Item Name: Crosstube Turning Detail

DART AEROSPACE LTD		Work Order:	140425
Description: Crosstube Assembly		Part Number:	D407-667-145
Inspection Dwg: D407-667-145 Rev: C		Page 1 of 2

DESIGN	9	DART AEROSPACE LTD	
DRAWN	RF	HAWKESBURY, ONTARIO, CANADA	
CHECKED	CP	DRAWING NO.	REV. C
MFG. APPR.	CP	D407-667-145	SHEET 4 OF 4
APPROVED	CP	TITLE	SCALE
DE APPR.	CP	CROSSTUBE ASSY (407 HIGH FWD)	NTS
DATE	08.11.06	COPYRIGHT © 2002 BY DART AEROSPACE LTD THIS DOCUMENT IS PRIVATE AND CONFIDENTIAL AND IS SUPPLIED ON THE EXPRESS CONDITION THAT IT IS NOT TO BE USED FOR ANY PURPOSE OR COMMUNICATED TO ANY OTHER PERSON WITHOUT WRITTEN PERMISSION FROM DART AEROSPACE LTD.

DRAWING NO. D407-667-145	TITLE CROSSTUBE ASS'Y (407 HIGH FWD)	REV. C	DART AEROSPACE LTD ENGINEERING ORDER		D.E.O. NO. D407-667-145-C-1	SHEET NO. SHEET 1 OF 1	SCALE NTS
DRAWN <i>Q</i>	CHECKED <i>ASS</i>	MFG. APPR. <i>AB</i>	APPROVED <i>WD</i>		DE APPR. <i>H</i>		
DATE 11.07.15	DATE 11.07.22	DATE 11.07.22	DATE 11/07/22		DATE 11.07.21

DETAIL P
BONDING STRAP INSTALLATION 2 PL

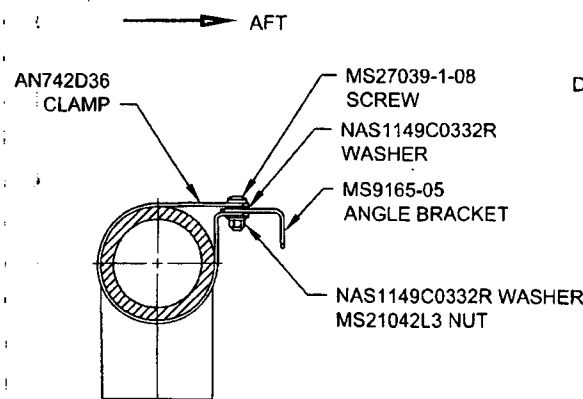
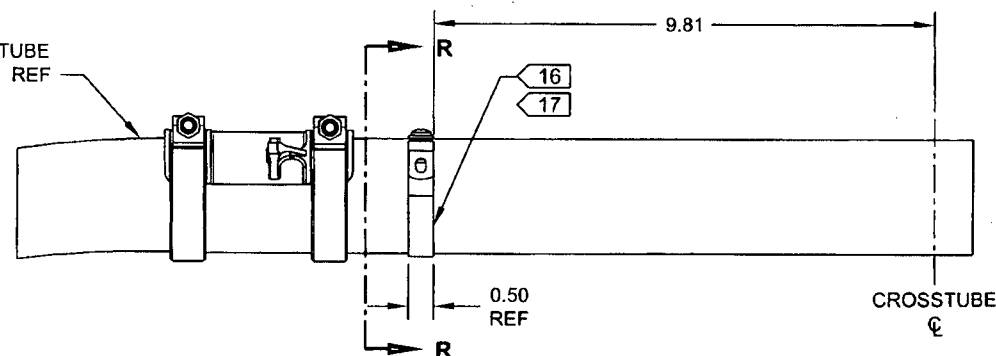
ADD ELECTRICAL GROUNDING STRAP

ITEM	QTY -145	PART NUMBER	DESCRIPTION
1	X	D407-667-145	CROSSTUBE ASSEMBLY (407 HIGH FWD)
<i>[Lightning Bolt Symbol]</i>			
10	2	AN742D36	CLAMP
11	2	MS9165-05	ANGLE BRACKET
12	2	MS21042L3	NUT (OR MS21042-3)
13	2	MS27039-1-08	SCREW
14	4	NAS1149C0332R	WASHER (OR AN960C10L)

- 16) MASK AREA UNDER CLAMP PRIOR TO PAINTING
- 17) SEAL EDGES WHERE AN742D36 CLAMP MEETS WITH THE CROSSTUBE USING SIKAFLEX-241/-291 OR MIL-S-8802 CLASS B2 OR PROSEAL 890 SEALANT
- 18) PERFORM RESISTANCE CHECK TO ENSURE MAX RESISTANCE IS 10 MILLIOHMS
